Multiple Sewershed - Package 5
Solicitation Number: CO-00237
Job No.: 17-4551

ADDENDUM 3
OCTOBER 26, 2018

PROJECT LOCATION 4 LAYOUT, BYPASS & CONTROL PLAN

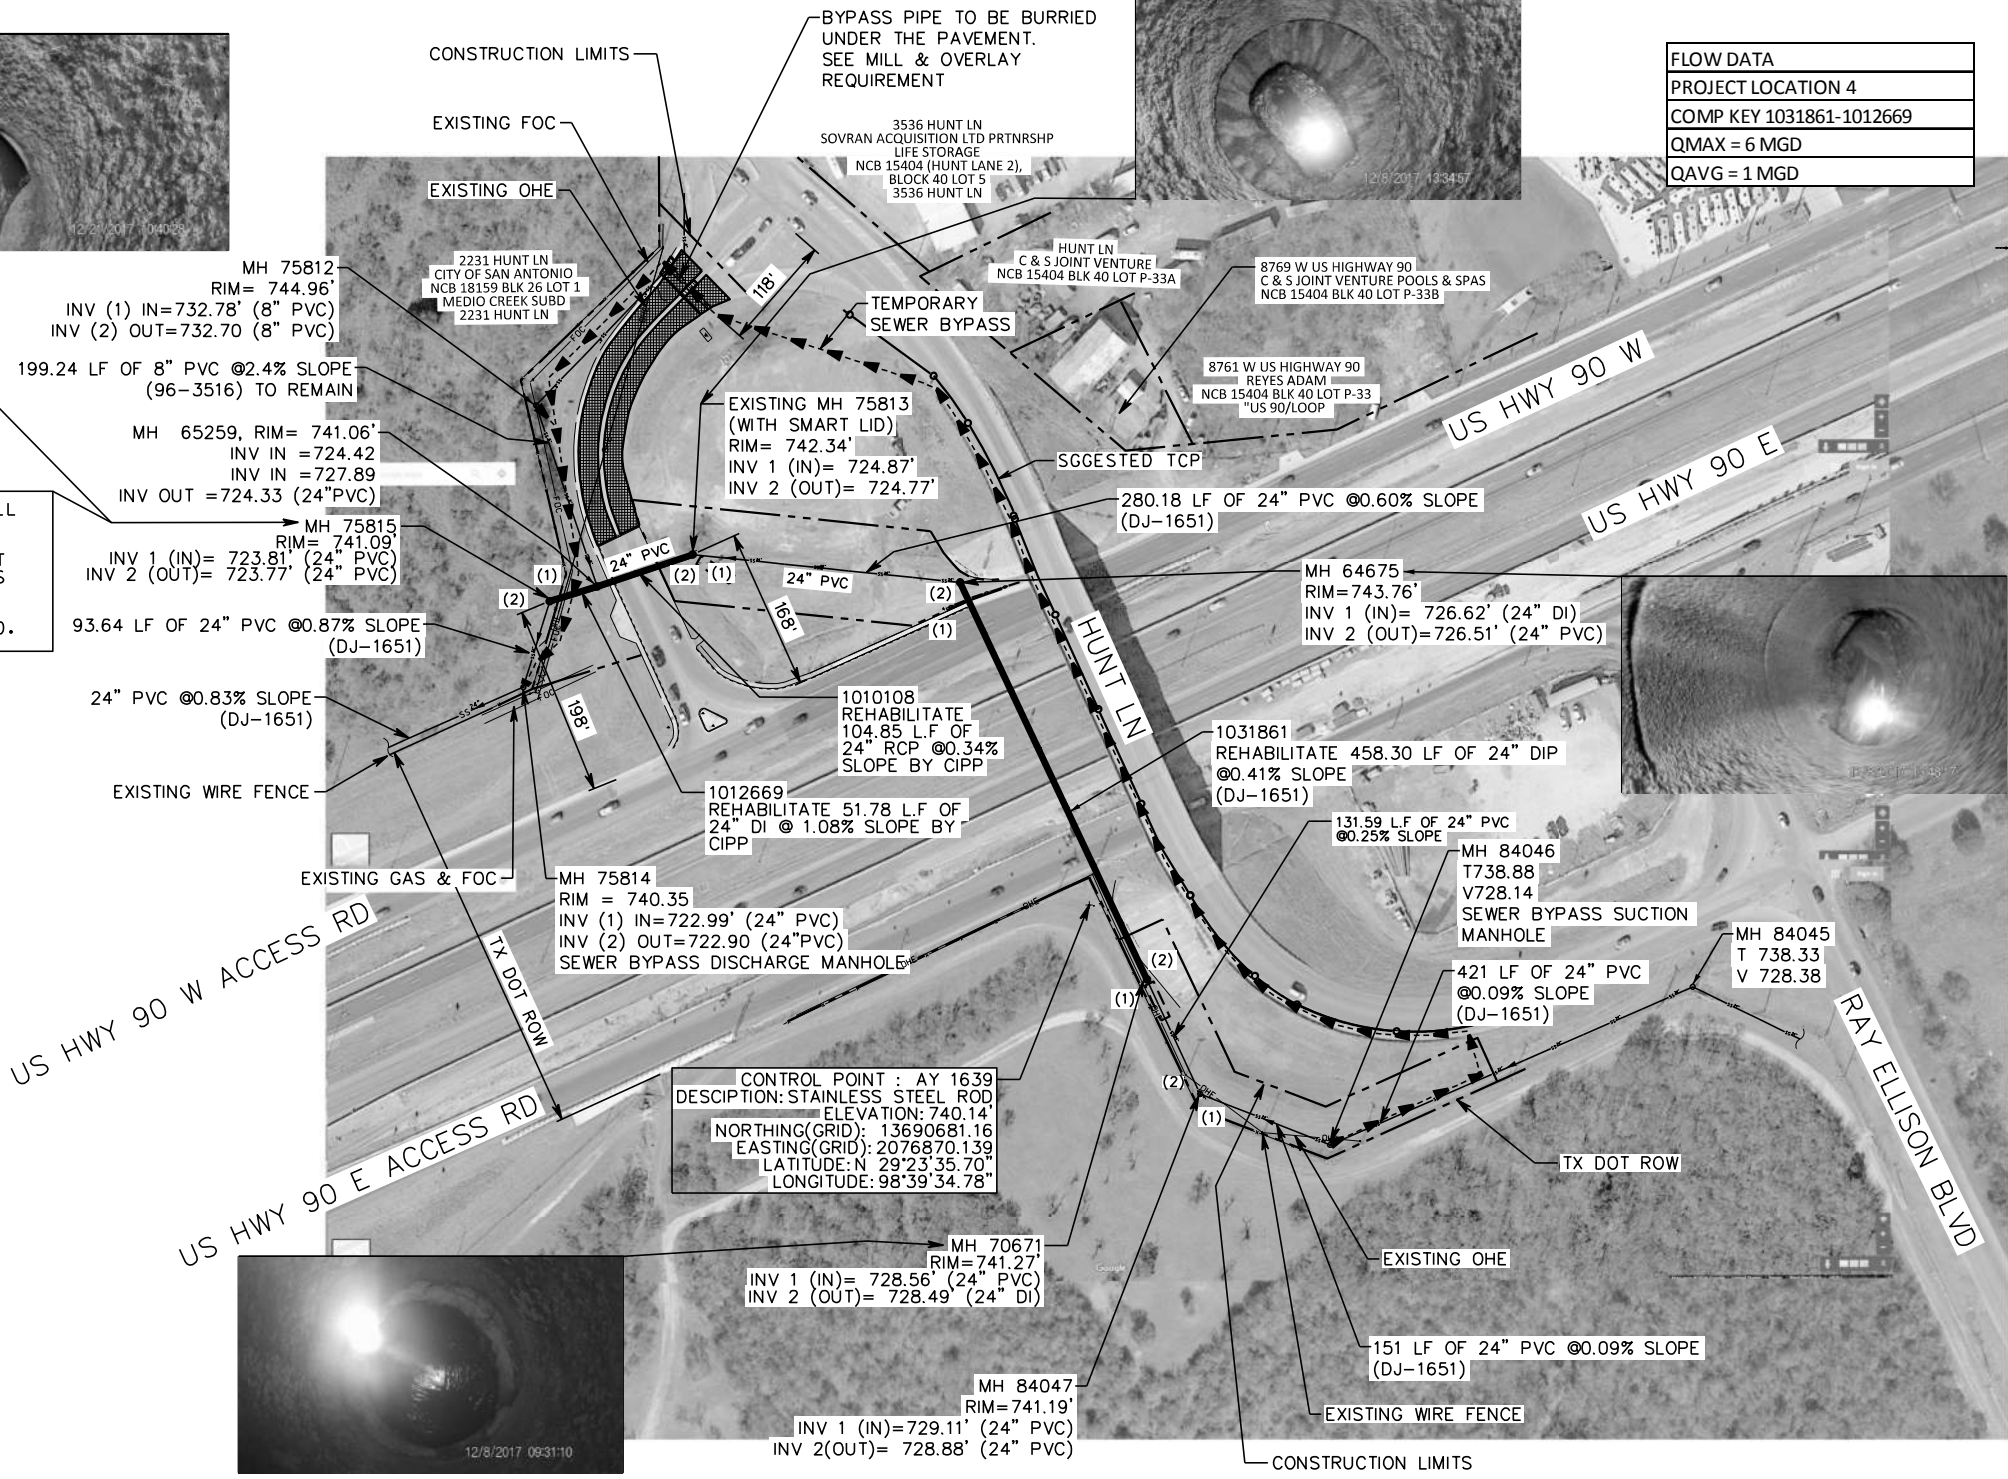
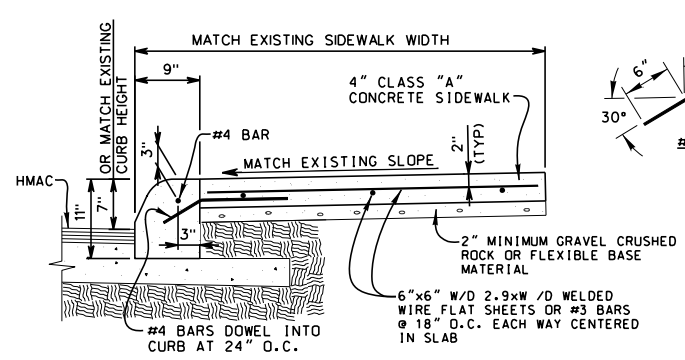
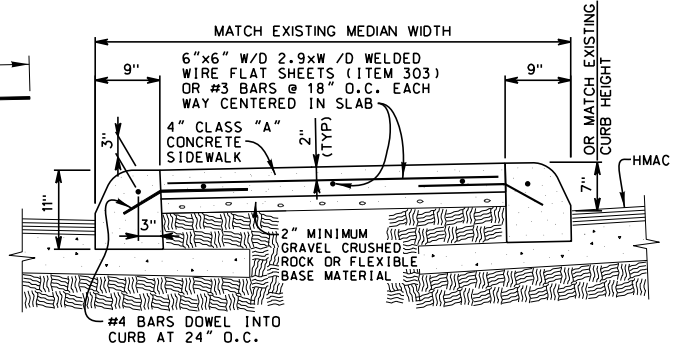
13. **Question:** At PL #4, there is a boxed note on the left side of drawing sheet 15 that says, "Contractor shall not excavate within this property". Please confirm that this is intended to apply to the City of San Antonio property noted as NCB 18159, Blk 26, Lot 1. If that is the correct property, then it appears that manhole 75815 is required to be reconstructed on that property, which will require excavation. Will excavation be allowed to reconstruct that manhole? Please clarify.

Response: *The said note "Contractor shall not excavate within this property" is intended to apply to the said CoSA property only. This property now belongs to SAWS. Excavations to reconstruct manhole 75815 will be allowed. See revised sheet 15 of 29.*

CONTRACTOR SHALL NOT EXCAVATE WITHIN THIS PROPERTY EXCEPT FOR EXCAVATIONS TO RECONSTRUCT MANHOLE 75815 WILL BE ALLOWED.

**PROJECT LOCATION 5
LAYOUT AND CONTROL PLAN**

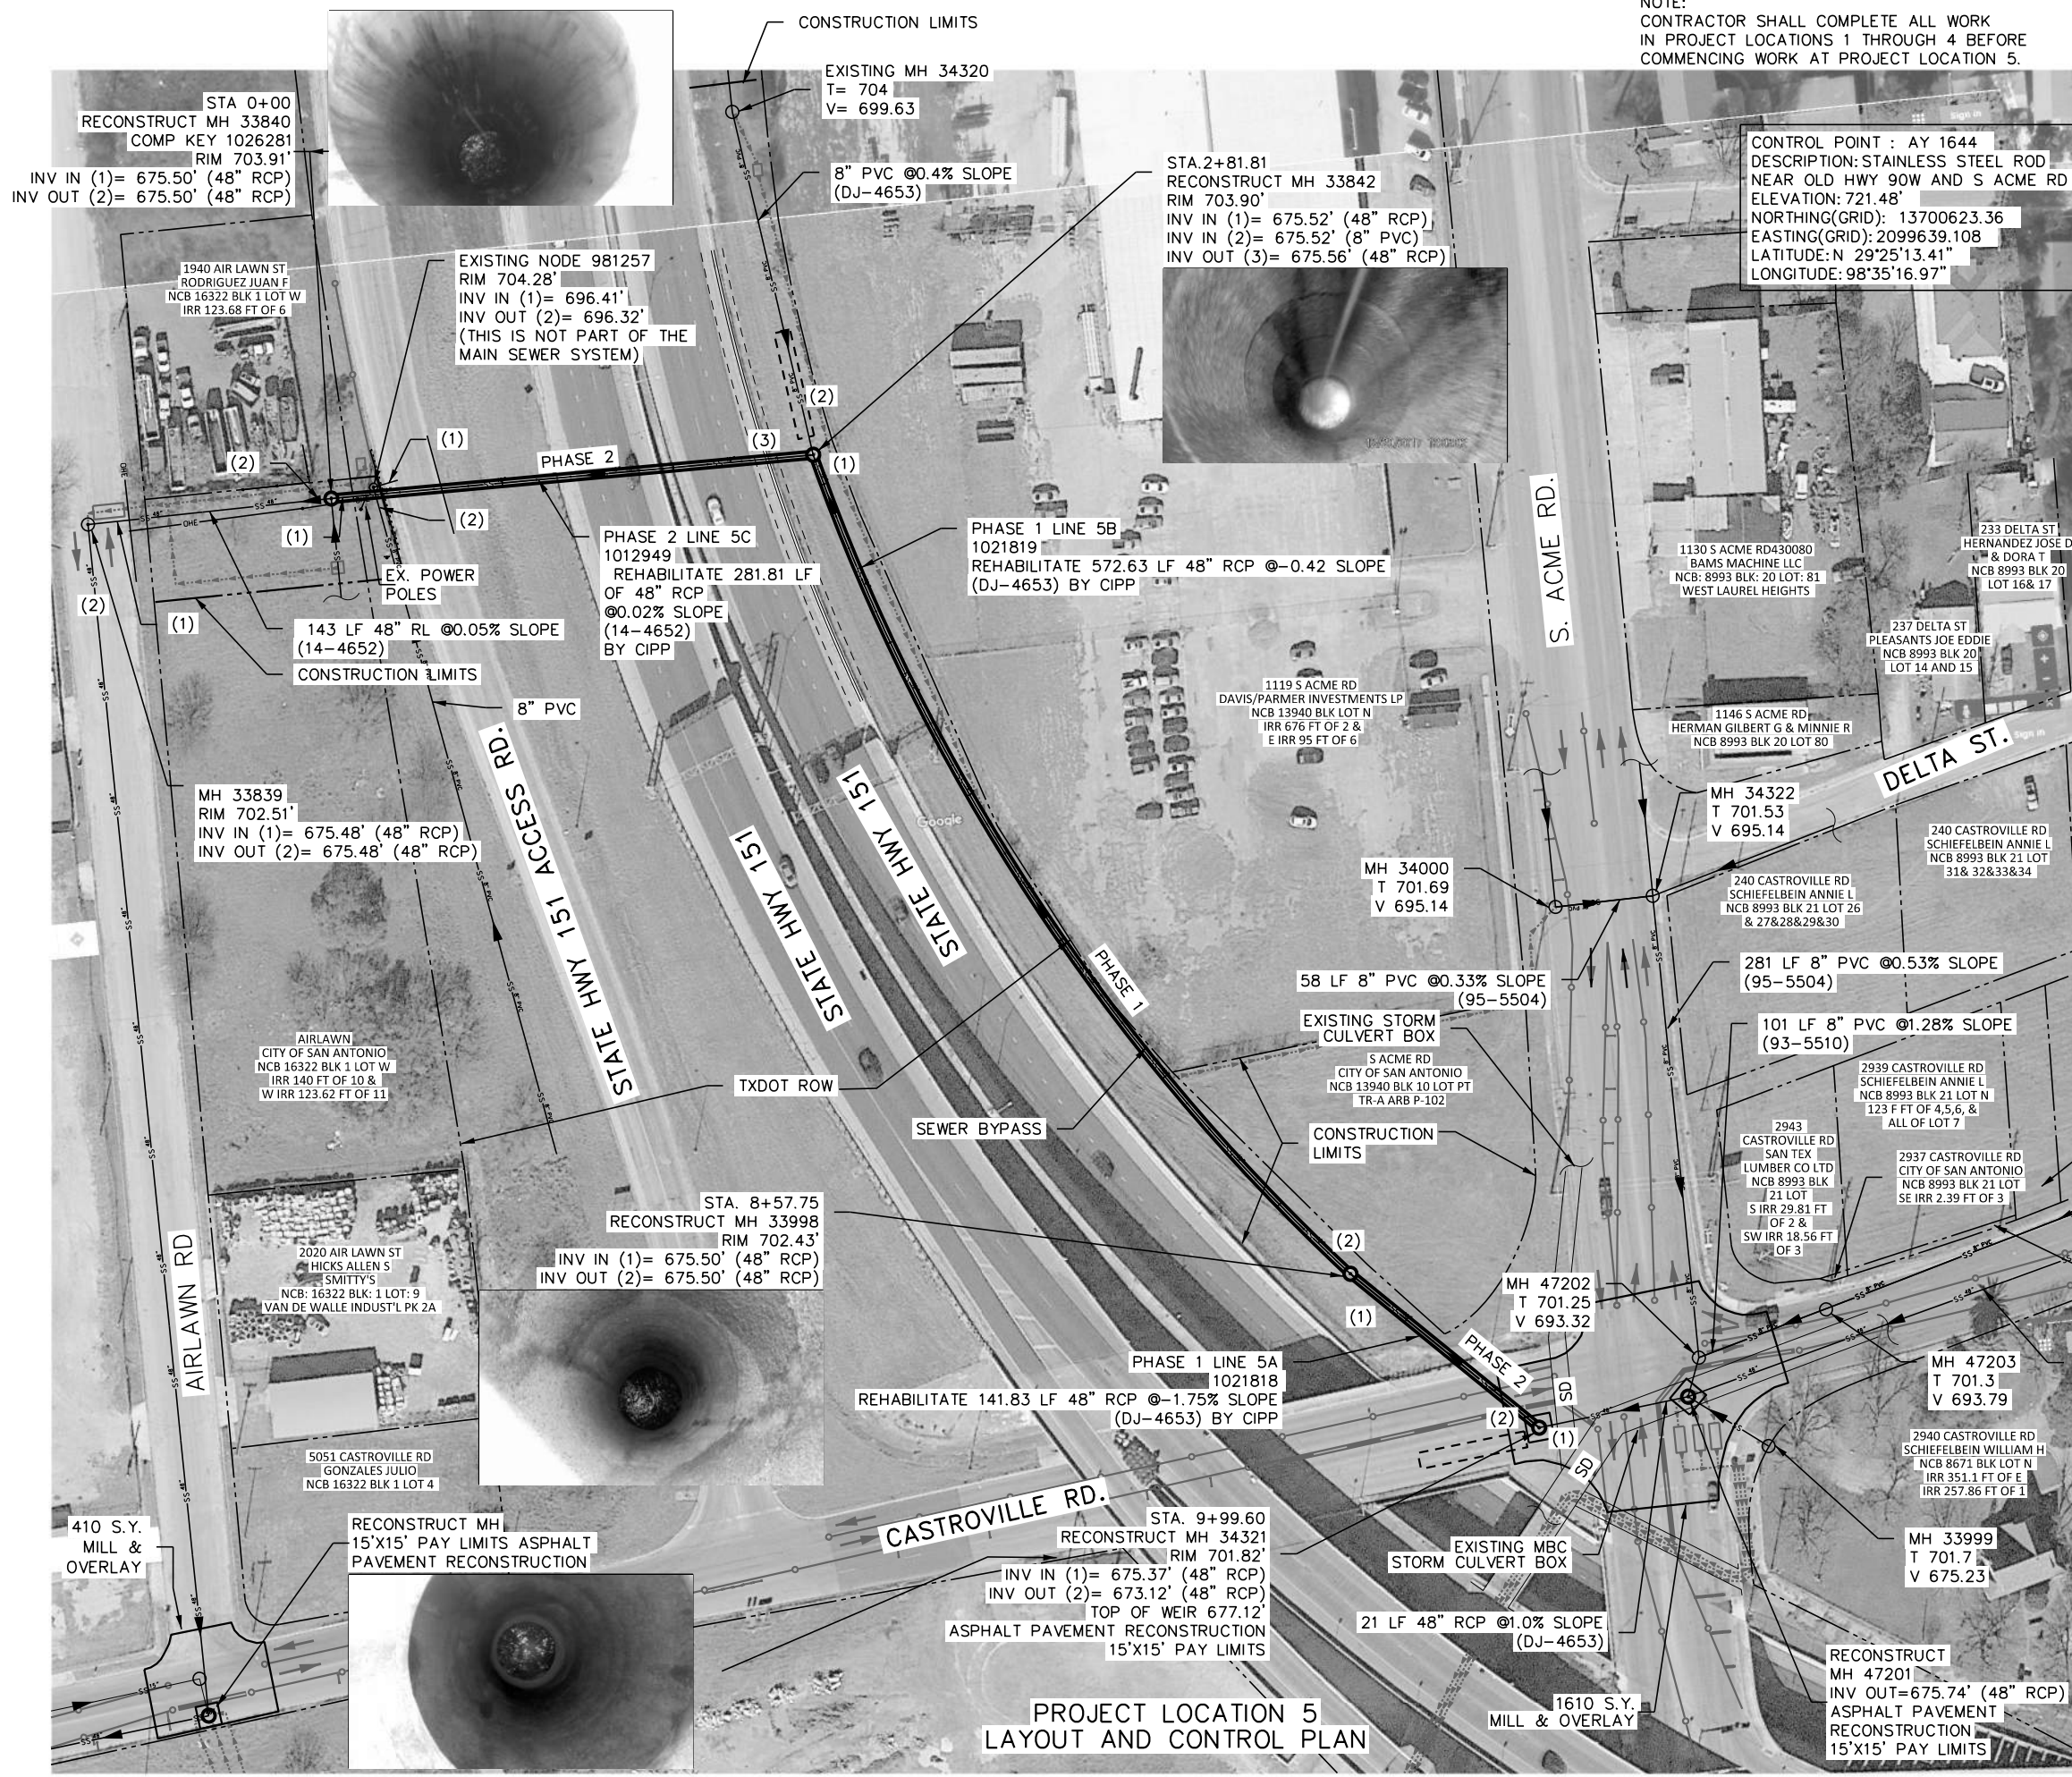
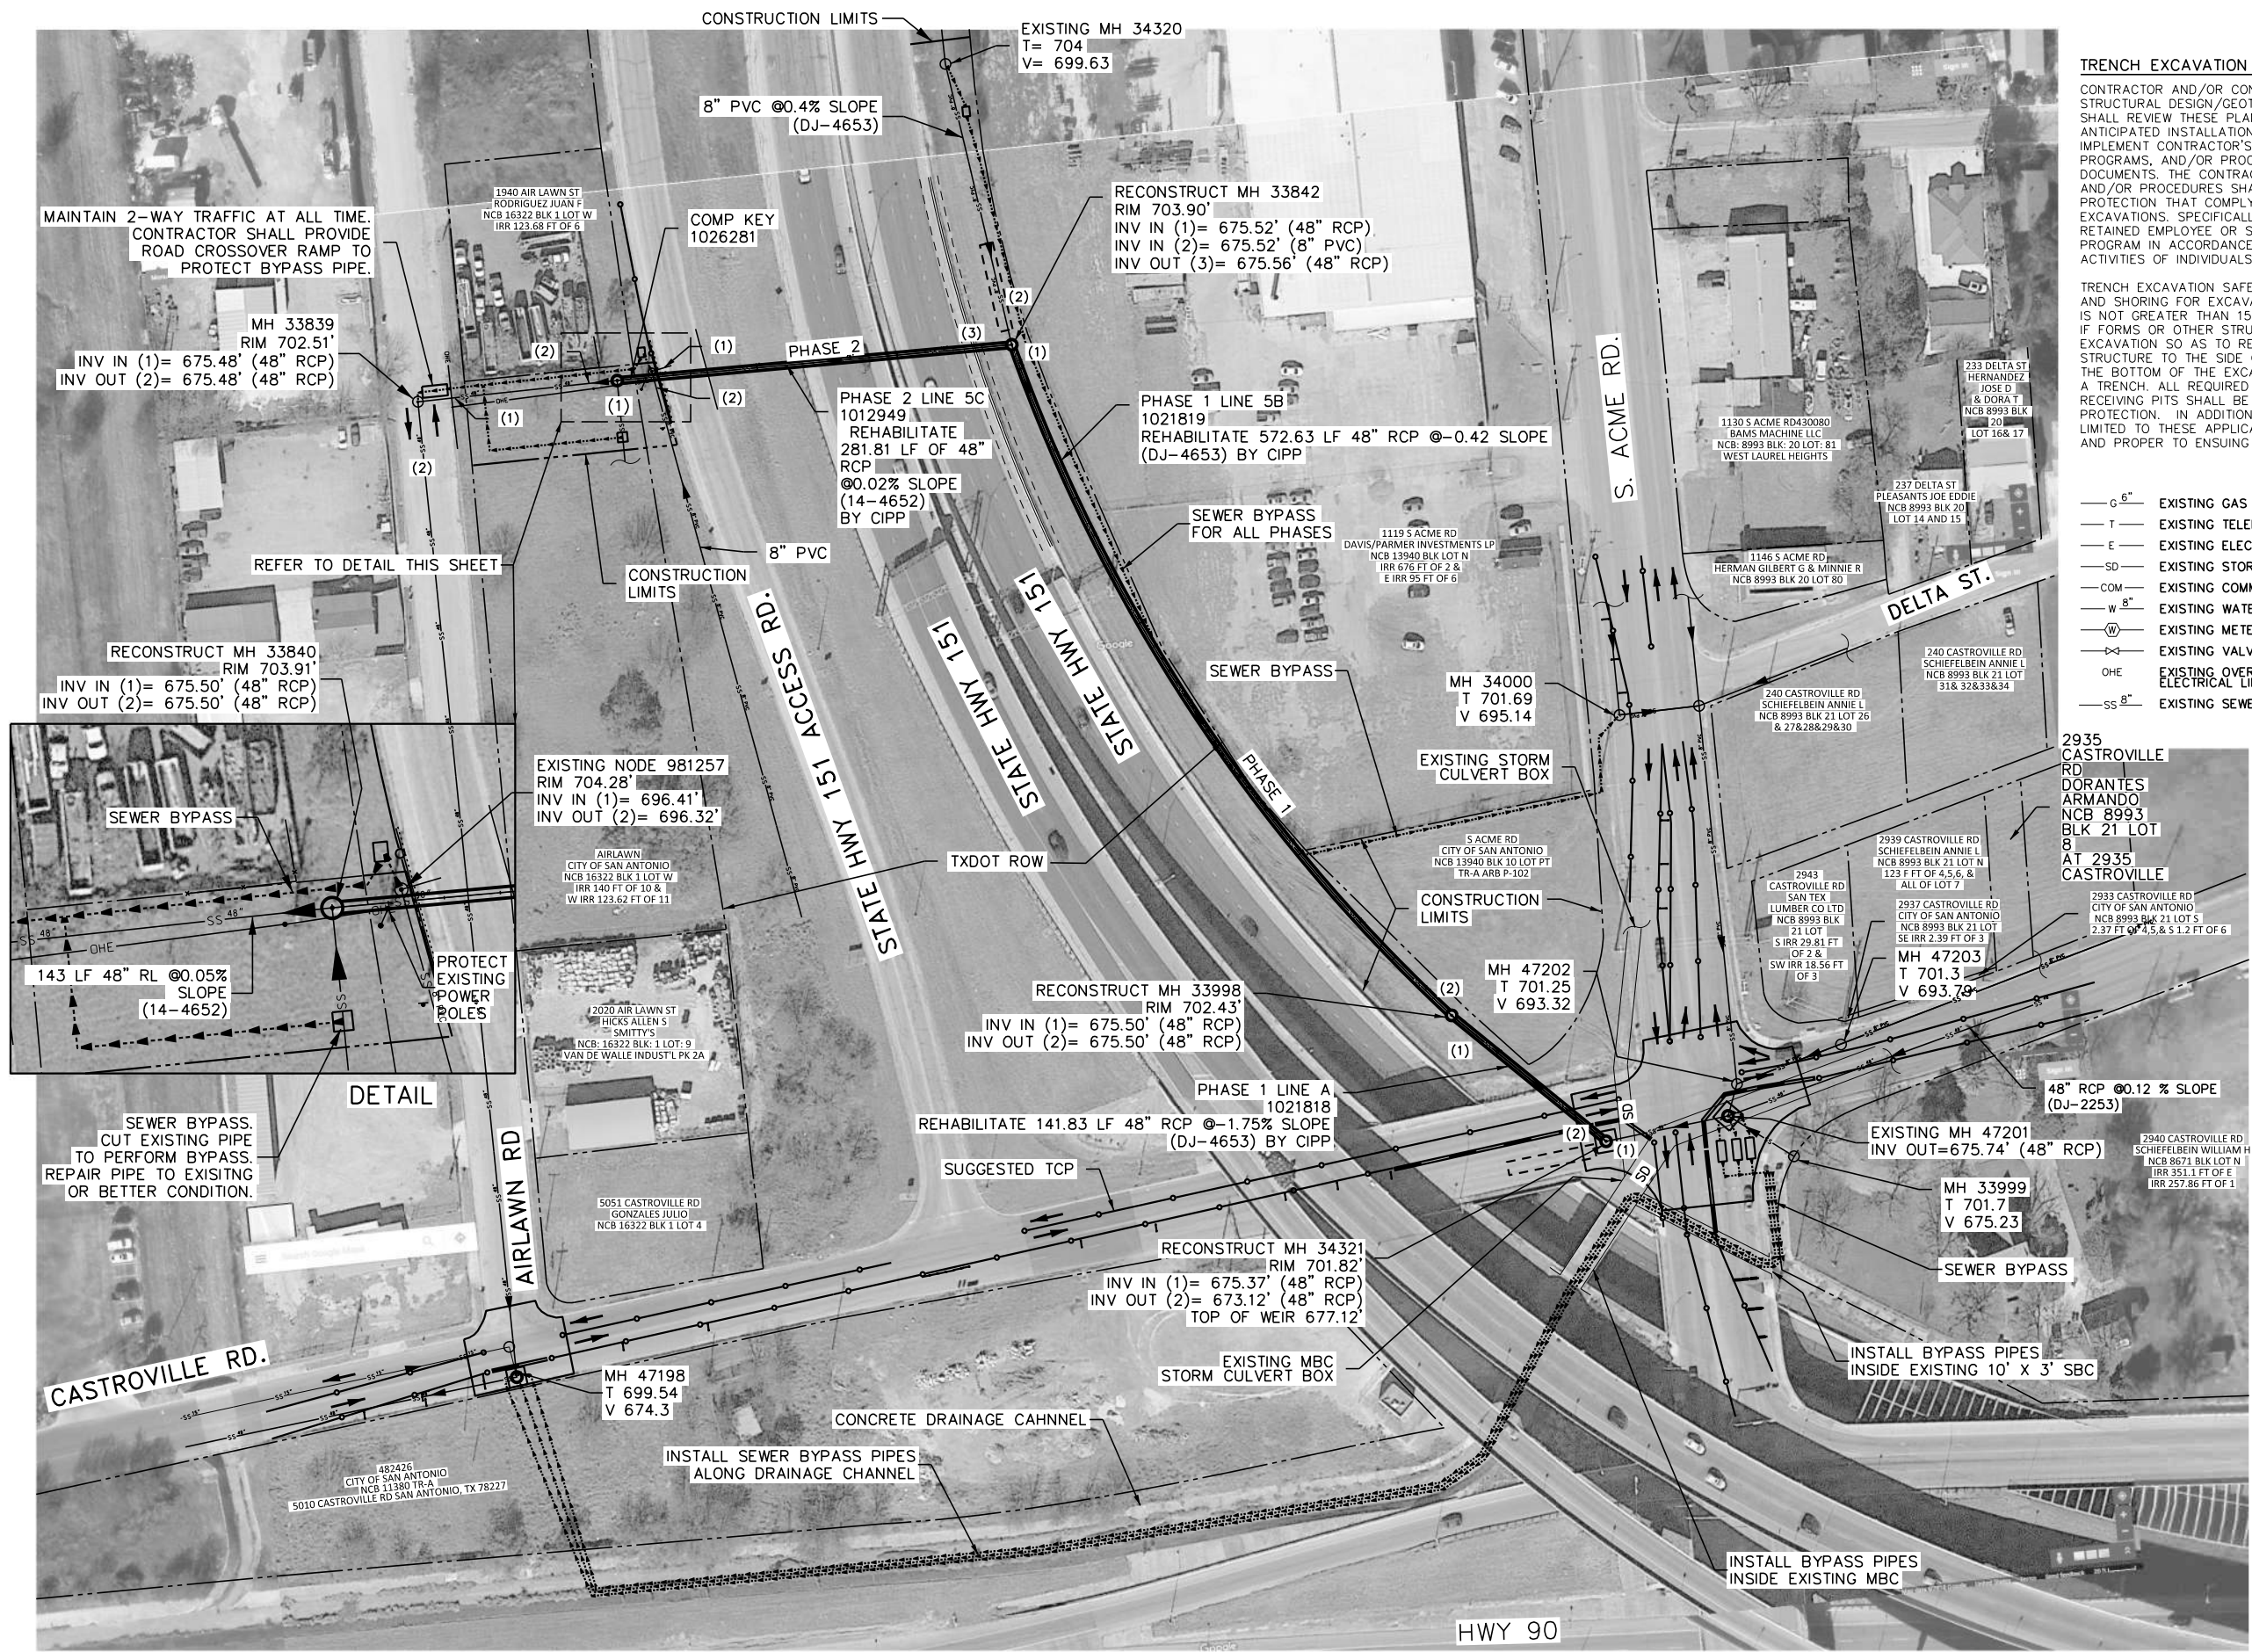
17. **Question:** At PL #5 for Additive Alternate B, there is a 410 SY mill & overlay shown at Castroville & Airlawn and a 1,610 SY mill & overlay shown at Castroville & Acme, which adds up to 2,020 SY. However, the bid quantity for this work is 2,392 SY. Is there another mill & overlay area at PL #5 for Additive Alternate B?

Response: Additive Alternate "B" has been combined into the Base Bid, and the said total quantity for mill & overlay has been revised to 2020 SY. Please see attached revised drawings.
